Historic Landmark Commission Agenda

July 21, 2021 at 6:00 P.M.

STAFF REPORT

Consider action to approve a Certificate of Appropriateness for 0.56 acres of Farm Lot 3, east of Main Street, located at 1607 Main Street, to remove the portico columns, rebuild the existing front porch, and add a wraparound porch on the first floor on the south side of the structure, for a Structure designated as locally Significant and on the National Register of Historic Places as the J.T.Crysup House.

FRONT (WEST) VIEW

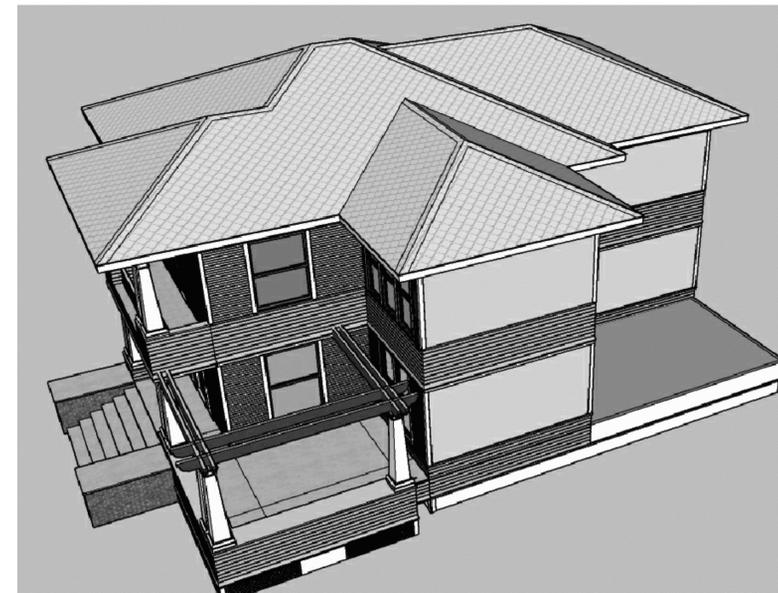
On the existing entry, the applicant is proposing to remove the columns for the portico, enclose part of the railing of the second story gallery, replace the existing classical style columns with double tapered columns, add additional steps from the porch to the walkway with brick wingwalls/planters on either side on the steps.

The applicant is also requesting to extend the front porch to the south and wrap around the front façade, with a heavy timber pergola (Attachment 3).

In general, the changes and addition to the front porch are compatible with the Prairie School Style and the architectural styles along Main Street.

Staff recommends the following changes to the design:

- The existing classical style columns seem to be a later addition however the new columns should be less tapered, a little less heavy, and include some inset design, similar to the design of the columns on the rear of the house.
- Upper story gallery should not be enclosed and remain with the open rail design.
- Wingwalls should be narrower and made out of wood. Brick is not an appropriate material for this style.
